RE: 4615-XXX - RFP 01 – Replace Sullivan Frames

WINDOW AND SIDING REPLACEMENT PHASE 2

Sheet Title:
PARTIAL FIRST FLOOR
DEMOLITION PLAN

Sketch Number:
ASK-006R1

SULLIVAN PARTIAL FIRST FLOOR DEMOLITION PLAN

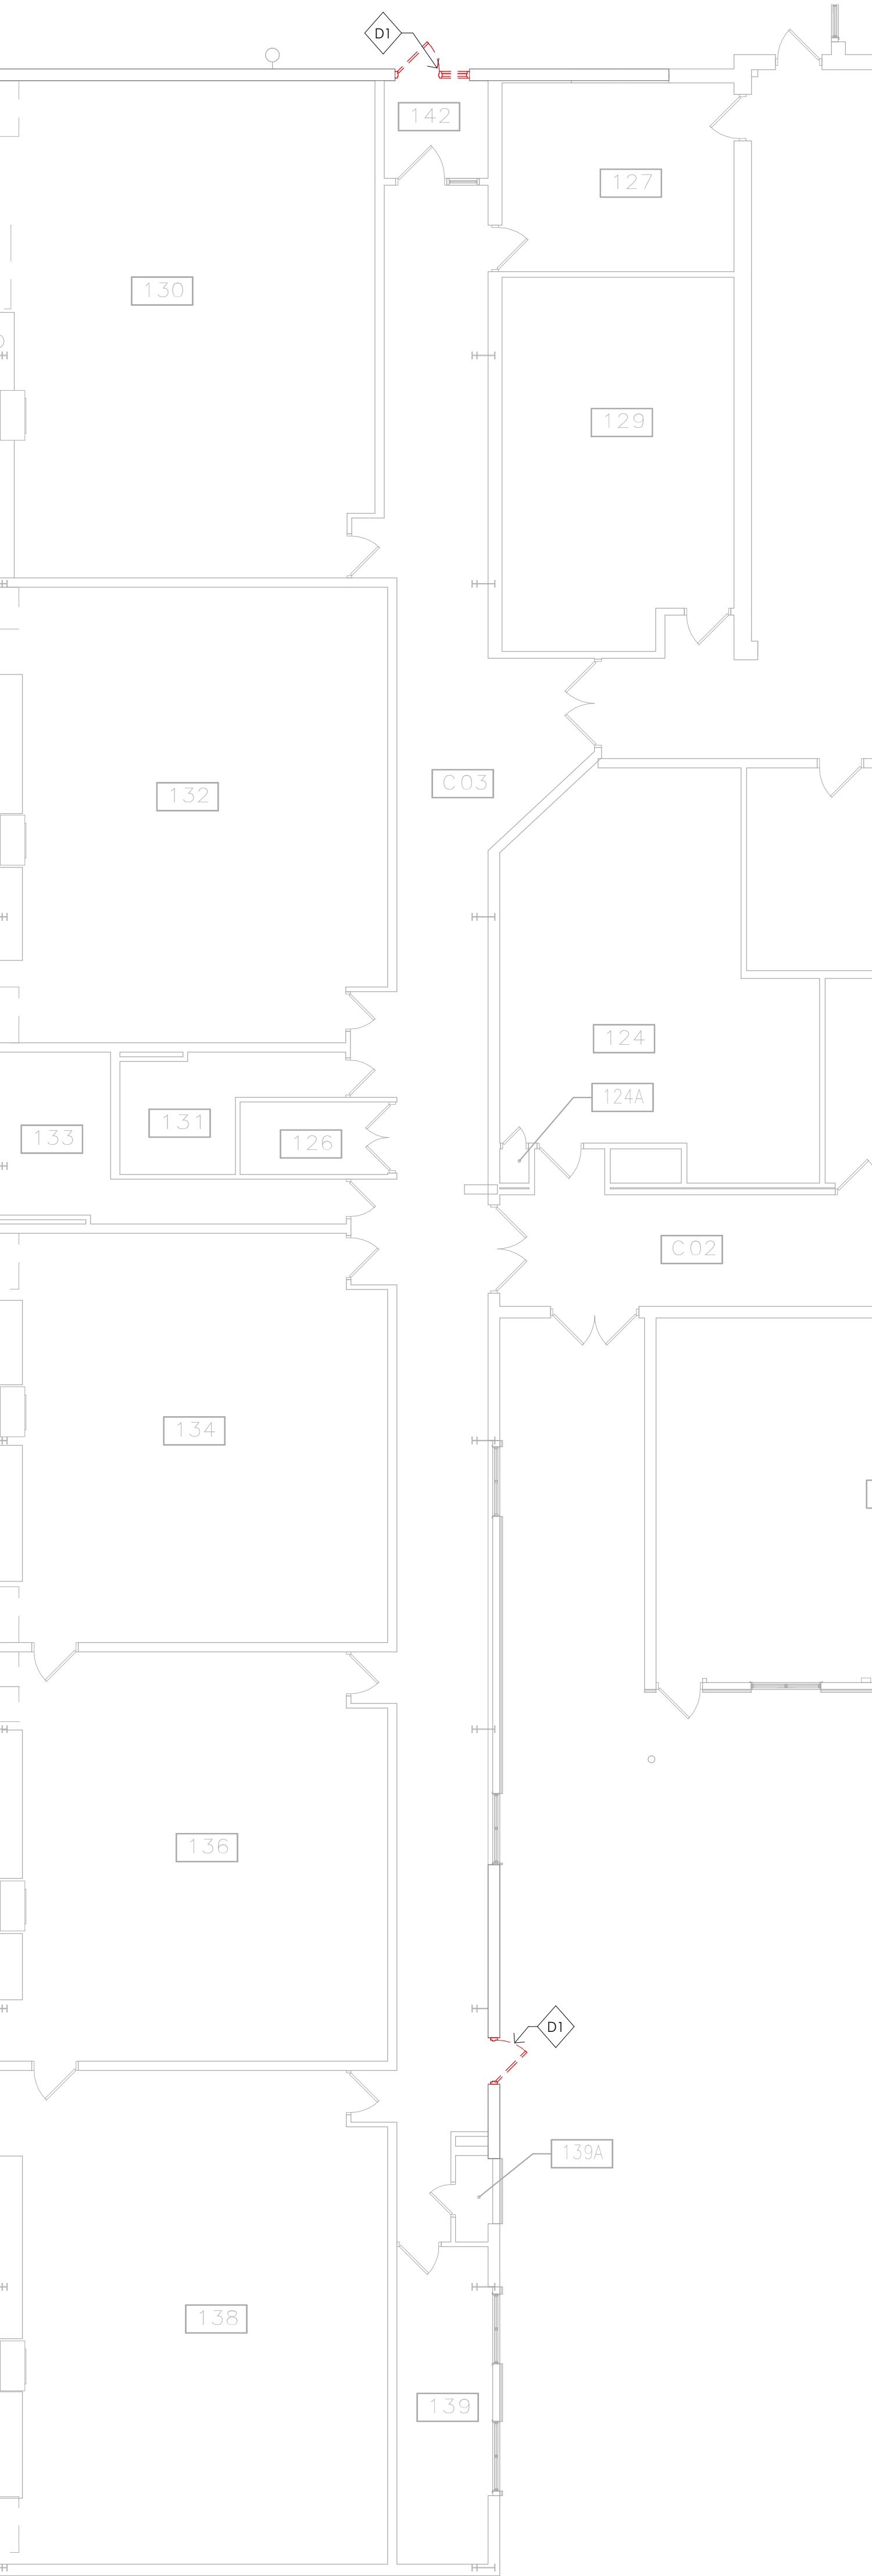
D1 **DOOR:** REMOVE & DISPOSE OF EXISTING FRAME AND FRAME GLAZING ONLY. REMOVE AND SALVAGE DOOR LEAF AND ALL HARDWARE FOR RE-INSTALLATION.

G1 **DOOR:** INSTALL NEW DOOR FRAME, NEW FRAME GLAZING, SALVAGED DOOR LEAF, AND SALVAGED HARDWARE.
